# Central Community College – Kearney Center

## Addendum 2

Wilkins Architecture Design Planning  
2908 West 39<sup>th</sup> Street, Suite A  
Kearney, Nebraska 68845  
308-237-5787

Date Issued: February 18, 2016  
Bid Date: February 23, 2016

Addendum No. 2  
Utility Crossing Exhibit  
Sheet Ref: C1.6  
Sketch Date: **02/18/2016**

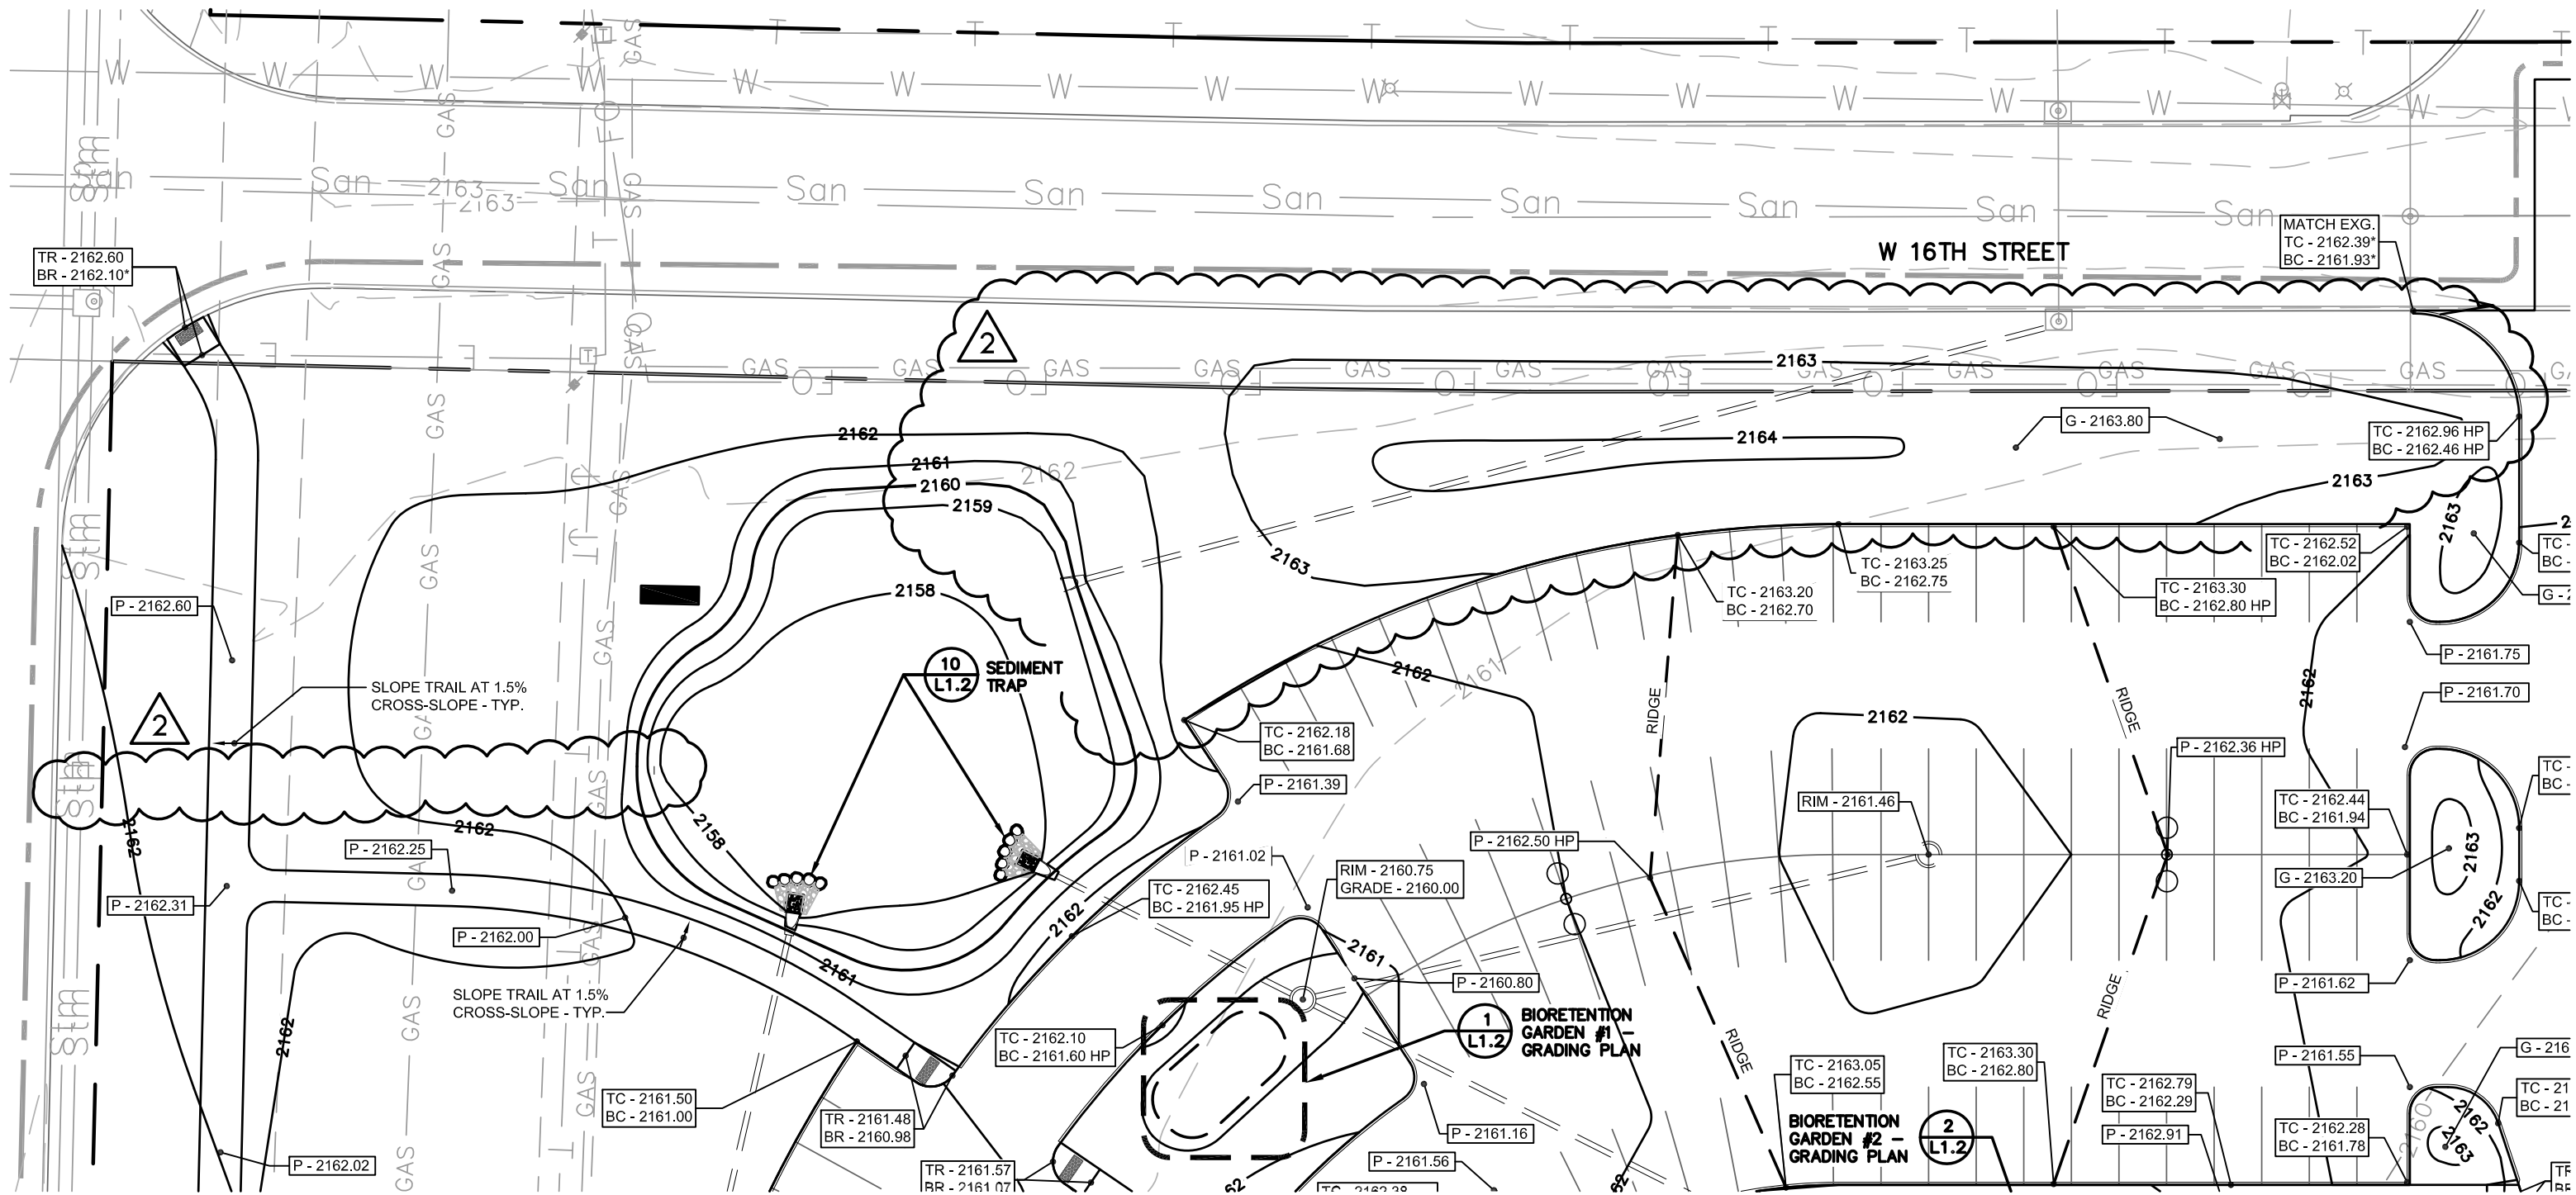
- Addendum 2 –30**     **Sheet C1.6 – Site Utility Plan**  
Add Utility Crossing information as outlined in attached sketch (CSK-01) and supporting STATUS OF UTILITIES narrative.

Conflict with the 4" communications conduit is not anticipated.

Conflict with the 4" gas main is not anticipated.

1  
A9.24  
**INTERIOR ELEVATION - COMPUTER LAB 124**  
SCALE: 3/8" = 1'-0"

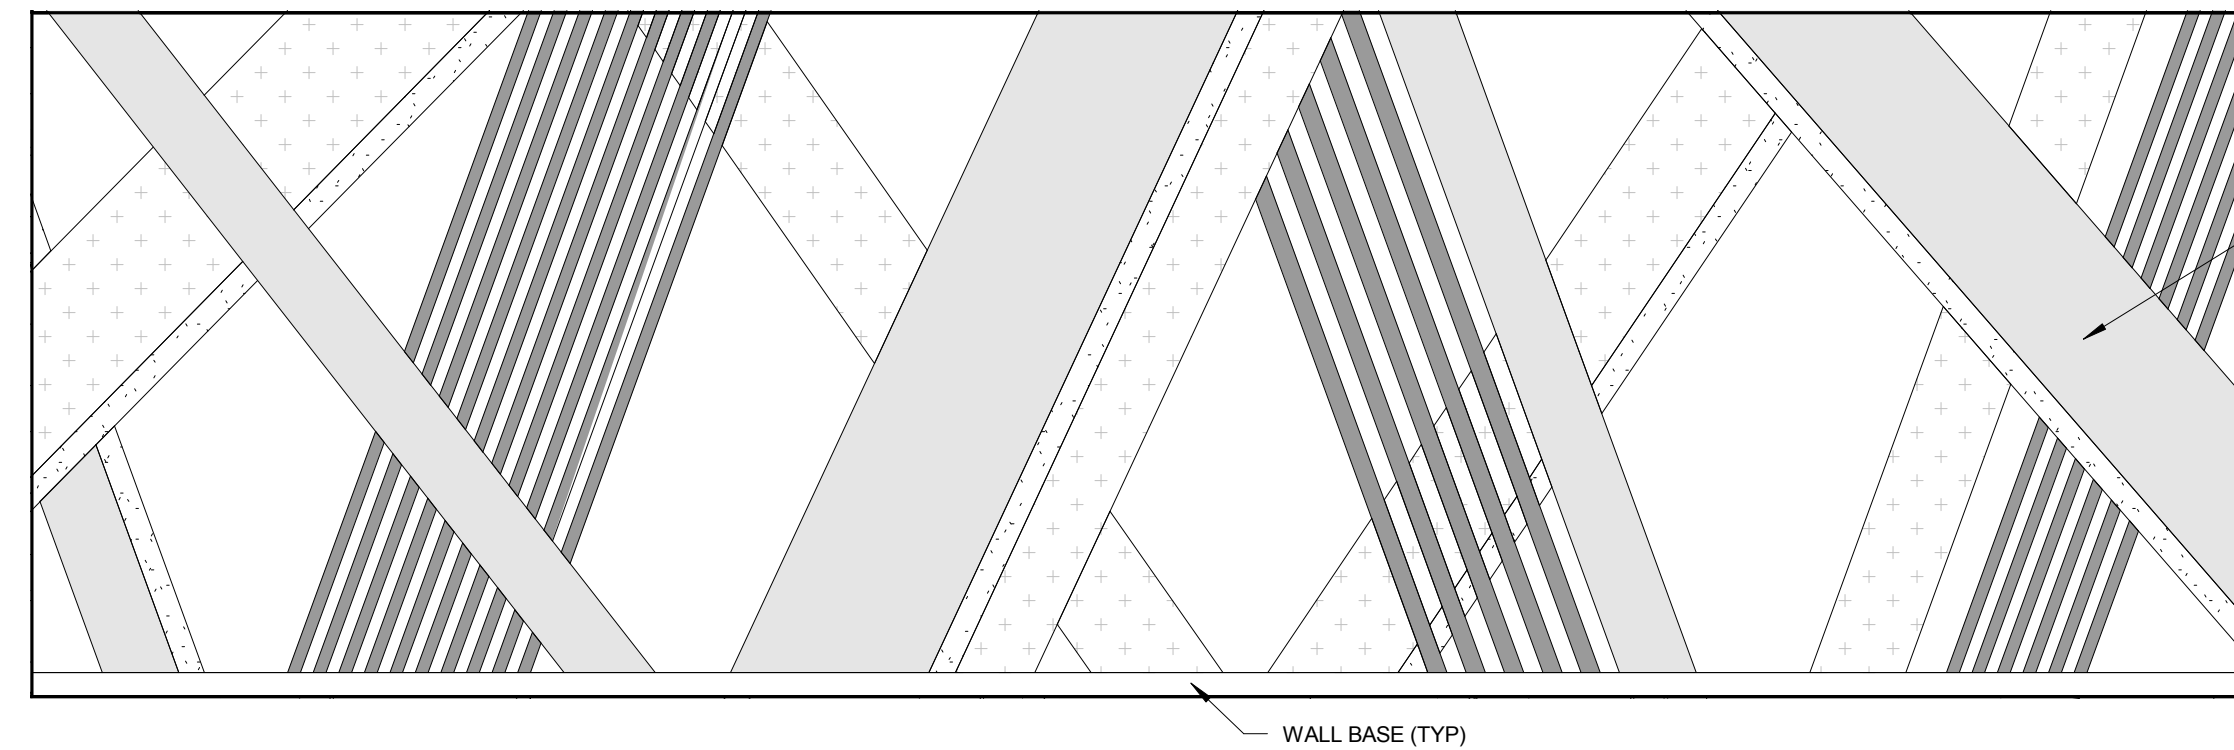
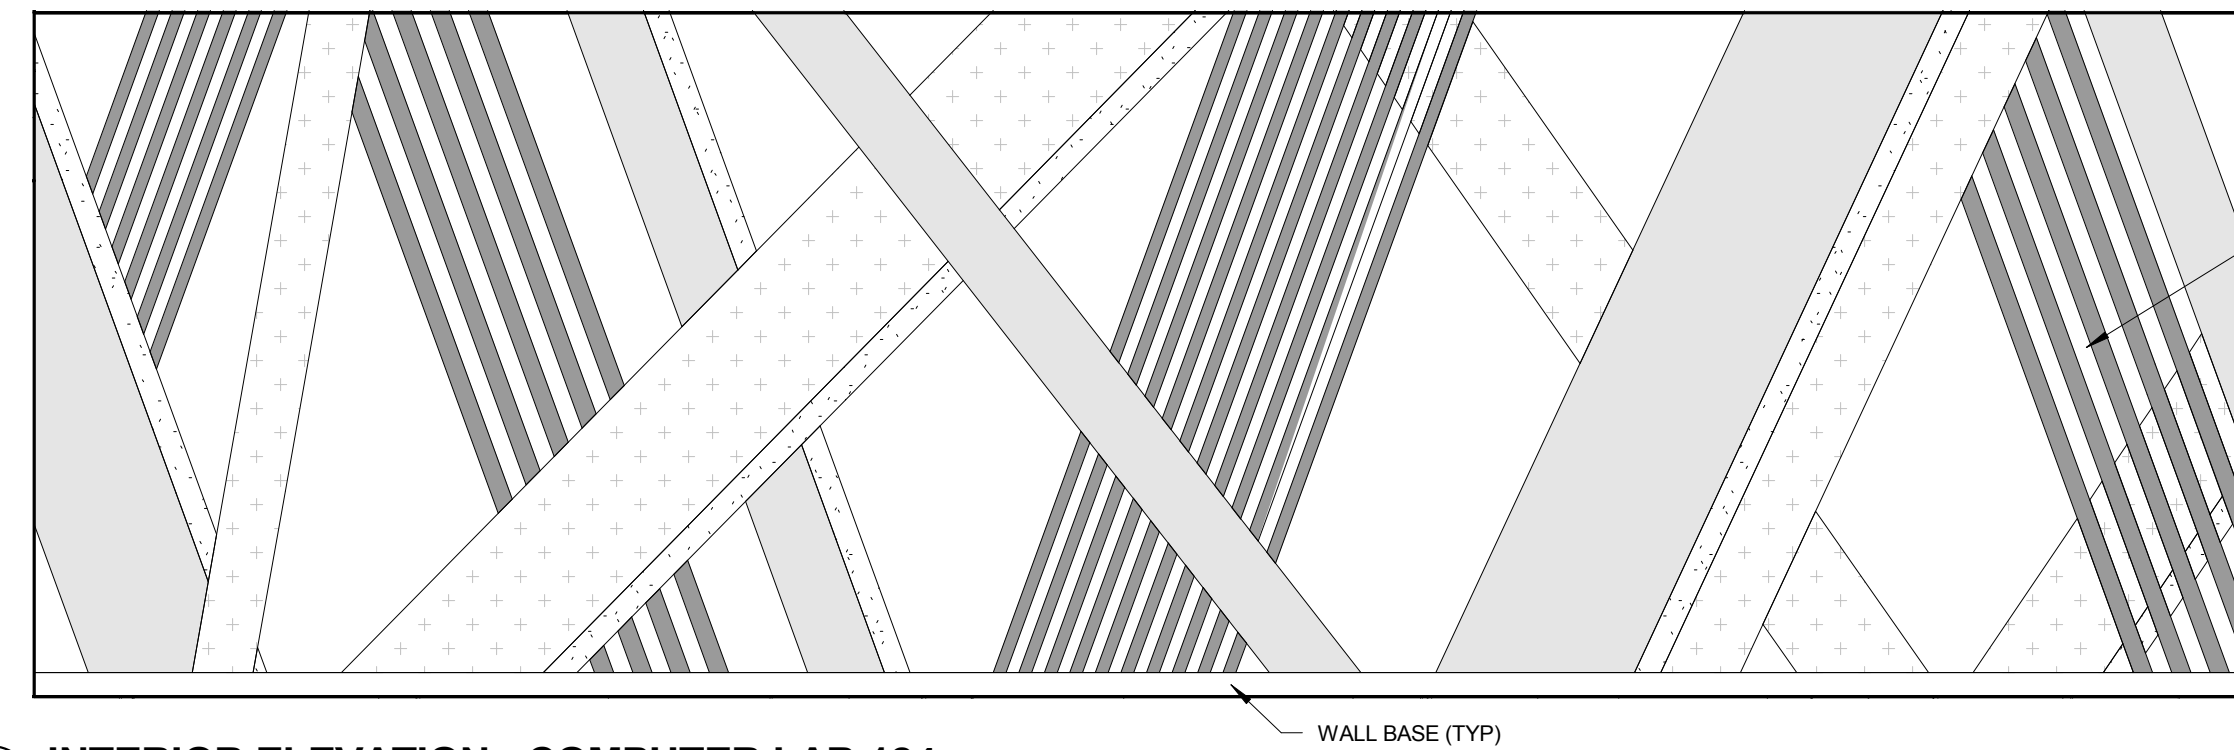
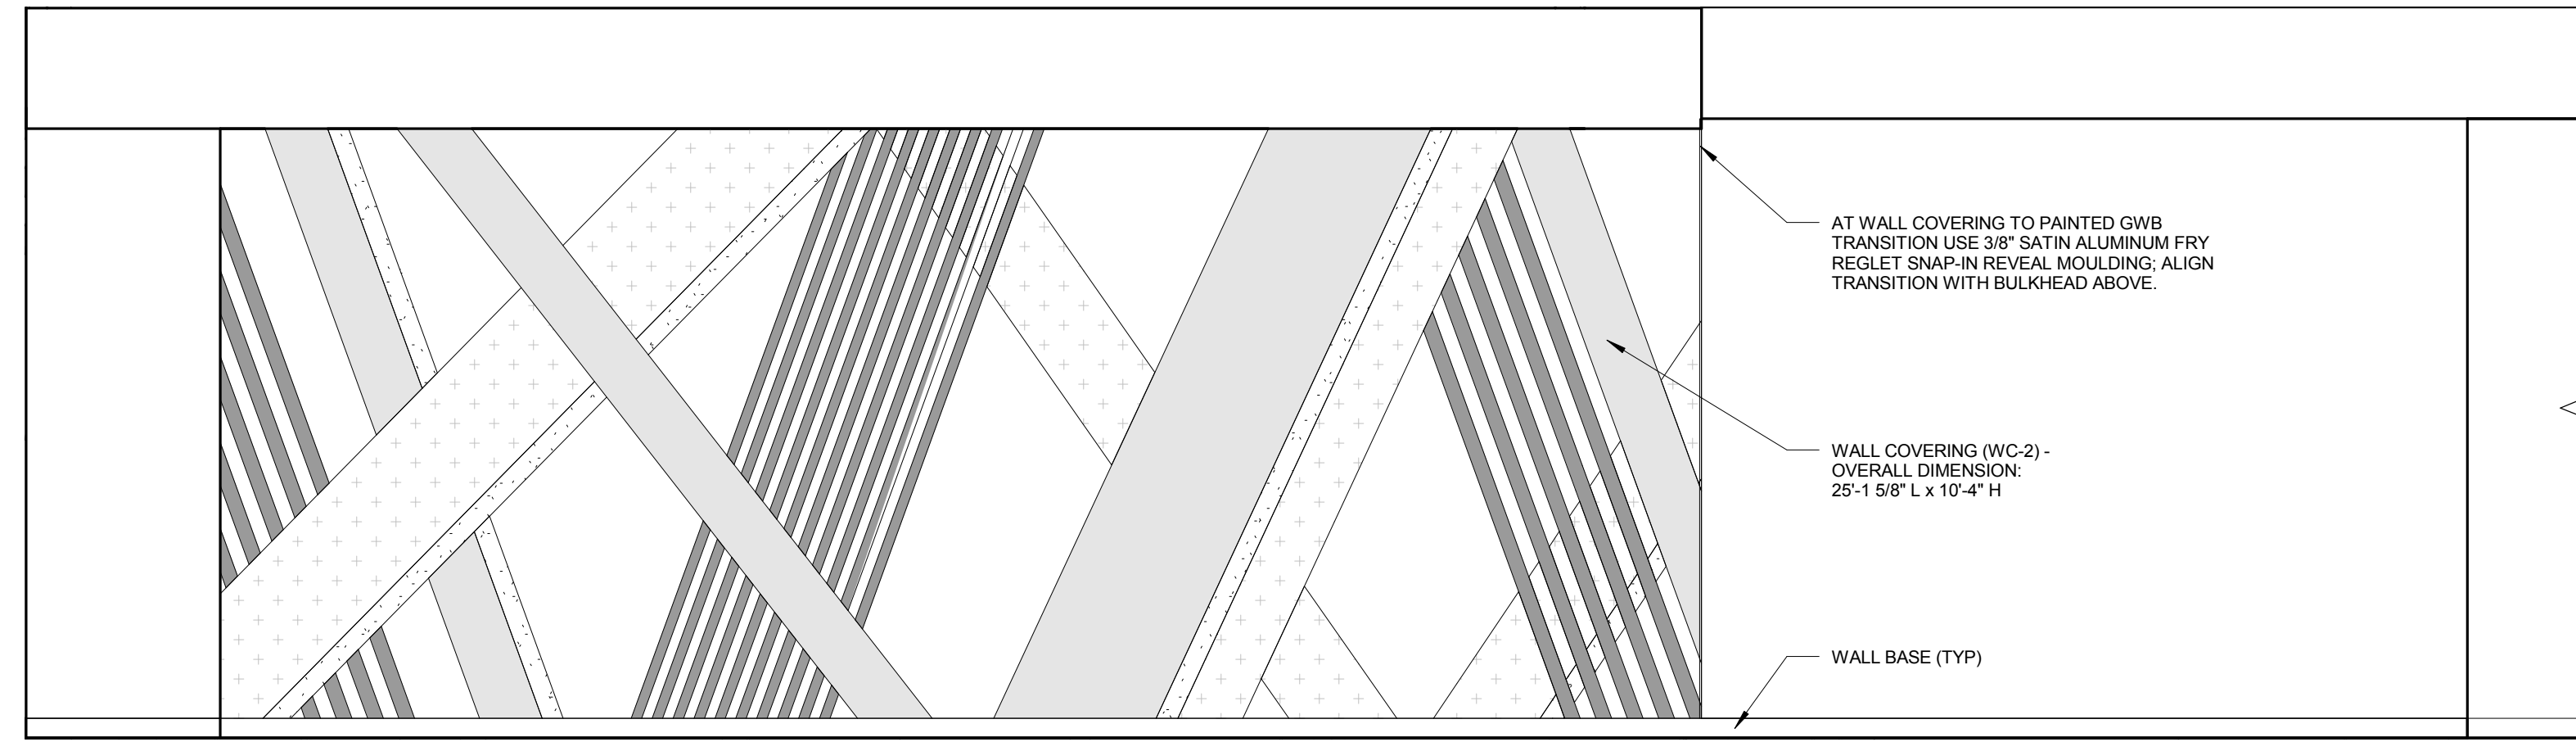
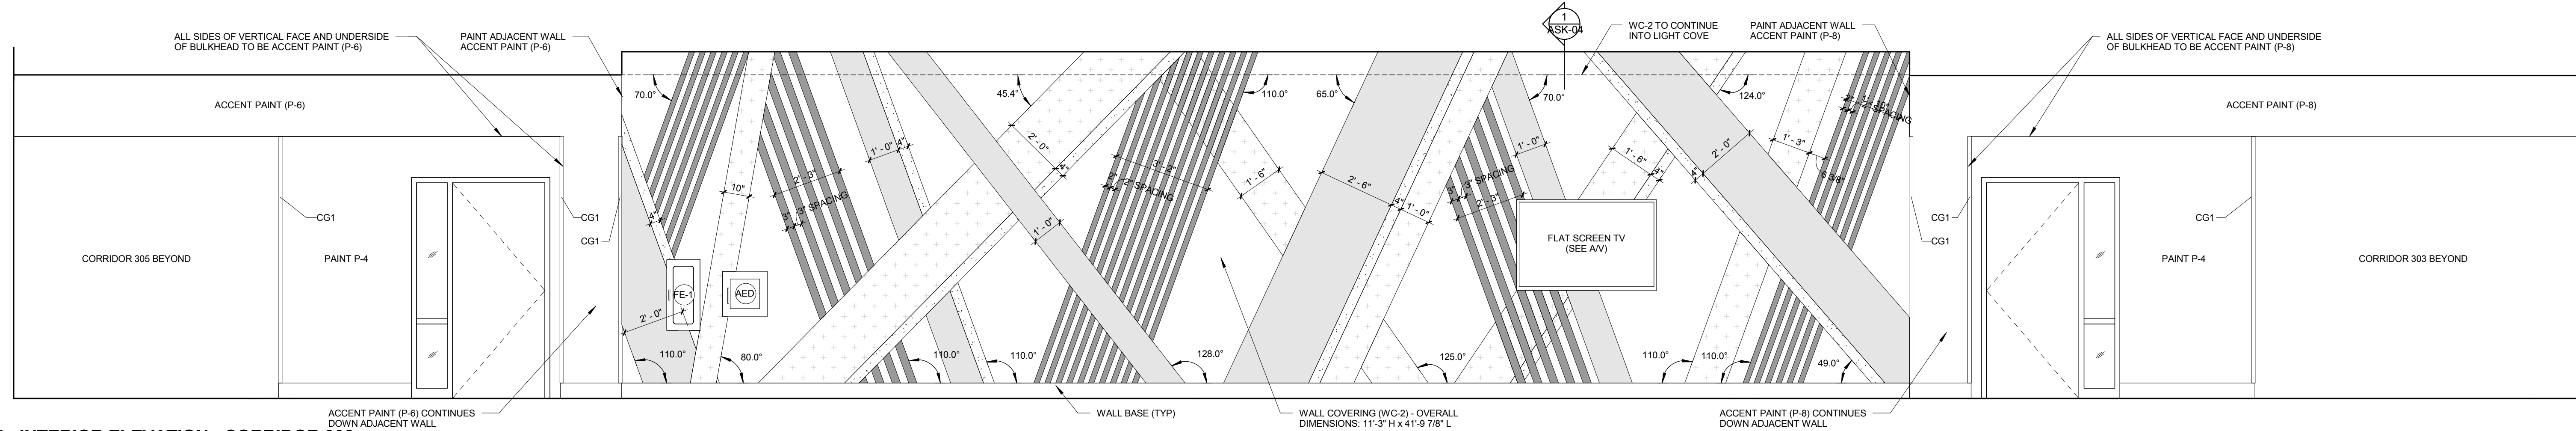
- Addendum 2 –52**     **Sheet A9.24 Interior Elevations**  
Insert into Construction Drawings attached architectural sheet A9.24 Interior Elevations
- Addendum 2 –53**     **Sheet A10.0 – Cabinet Sections**  
At detail 8/A10.0, delete all references to “WOOD GRAIN THERMOSET” finish; all

1 **CEILING DETAIL - DONOR WALL**  
ASK-13 SCALE: 1 1/2" = 1'-0"

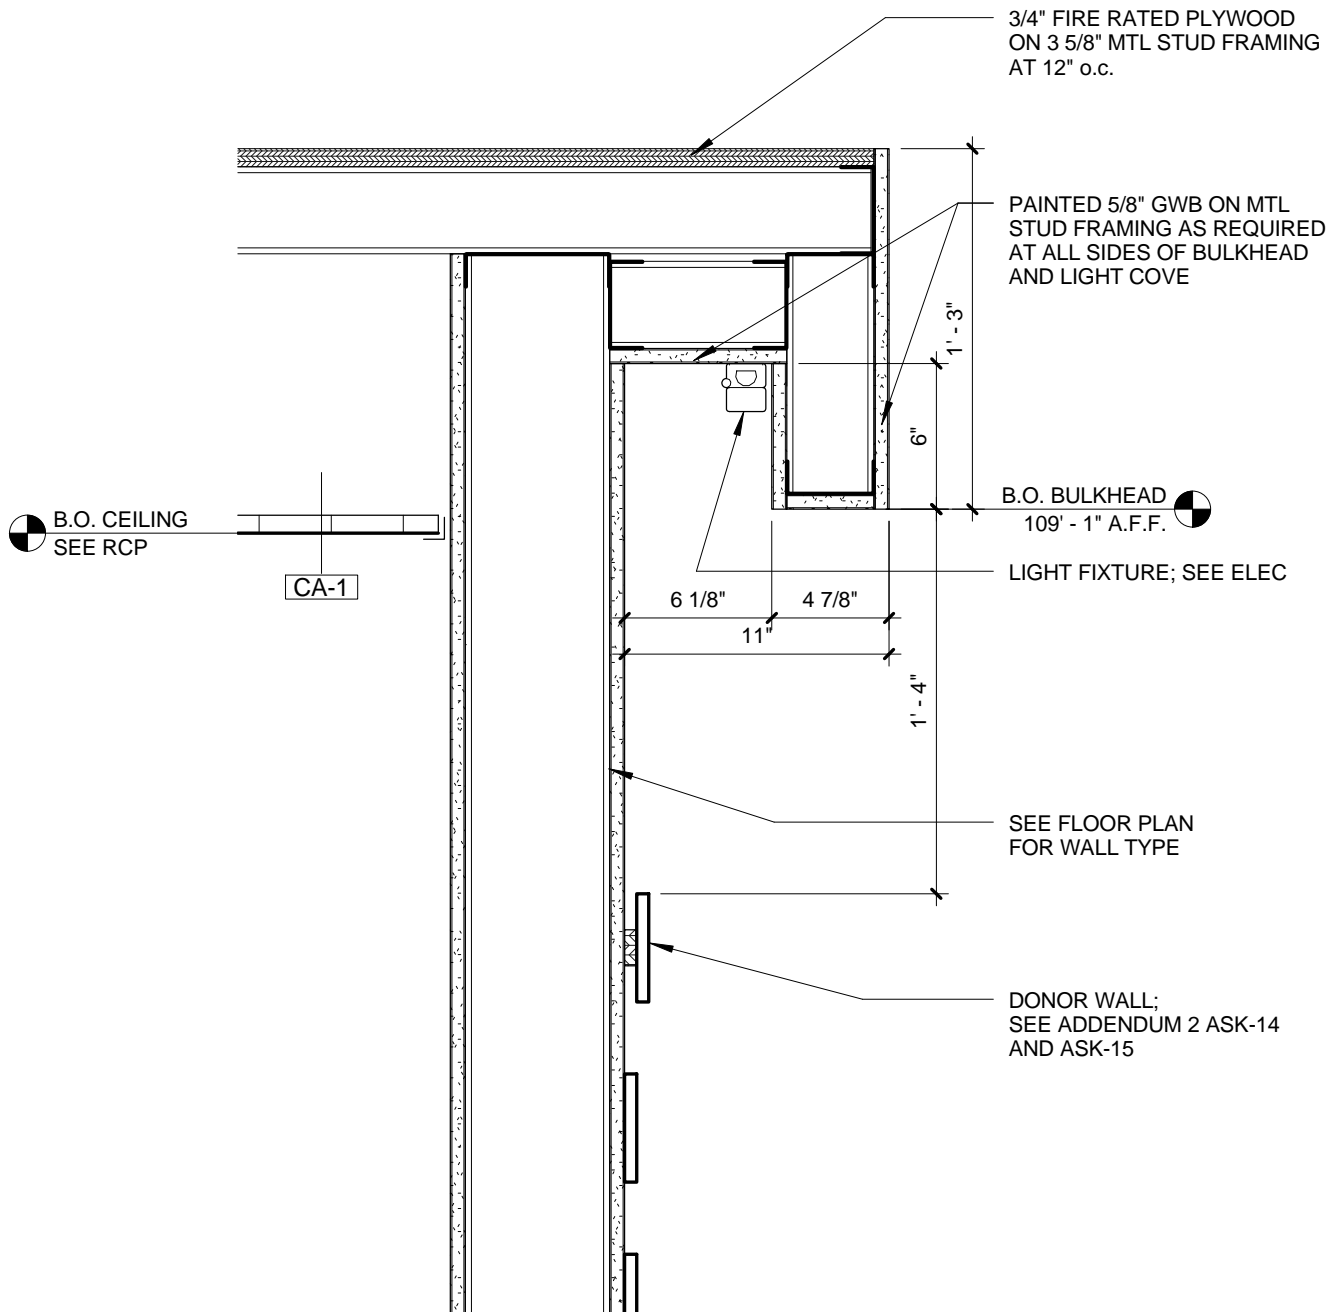
At 1/A1.1 FLOOR PLAN – AREA A, change dimension at overhead sectional door 150.1 to be 12'-0" in lieu of 10'-0"
- Addendum 2 –33**     **Sheet A3.1 Reflected Ceiling Plan – Area B**  
At 1/A3.1 REFLECTED CEILING PLAN – GROUND FLOOR – AREA B at west wall of ADMISSIONS OFFICE 214 add reference to detail ASK-13

Add detail ASK-13 to sheet
- Addendum 2 –34**     **Sheet A5.2 Enlarged Exterior Elevations**  
At 4/A5.2 ENLARGED EXTERIOR ELEVATION, at “PREFINISHED METAL GUTTER AND DOWNSPOUT” note add gutter size to be (6”) and downspout size to be (2”x3”)
